3.8 AUXILIARY ELECTRICAL SYSTEM

Duane Arnold Energy Center
Iowa Electric Light and Power Company
Technical Specifications

ENVIRONMENTAL CONSIDERATION

DAEC Emergency Service
Water Flow Requirement
Figure 4.8.E-1

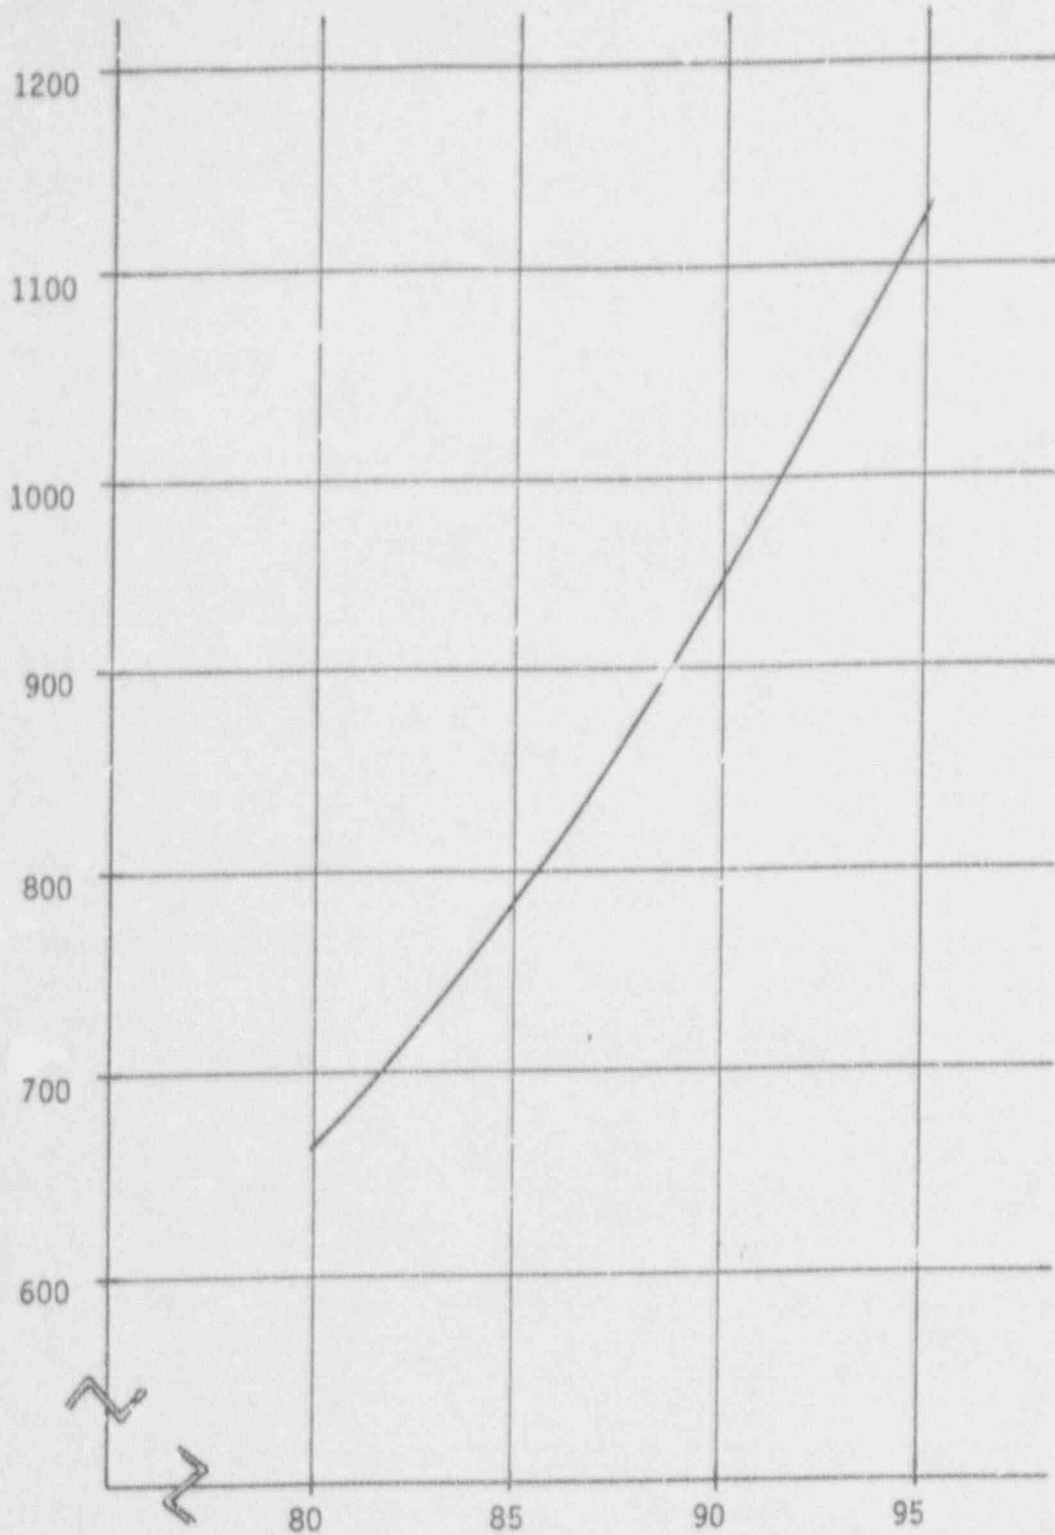
Each emergency service water pump shall deliver at least that flow determined from Figure 4.8.E-1 for the existing river water temperature.	After major pump maintenance and once per 3 months, except weekly during periods of time the river water temperature exceeds 80°F.
---	--
 2. With one emergency service water system pump or loop inoperable, the OPERABLE pump and loop shall be verified to be OPERABLE. In addition, the requirements of Specification 4.5.G.1 shall be met.
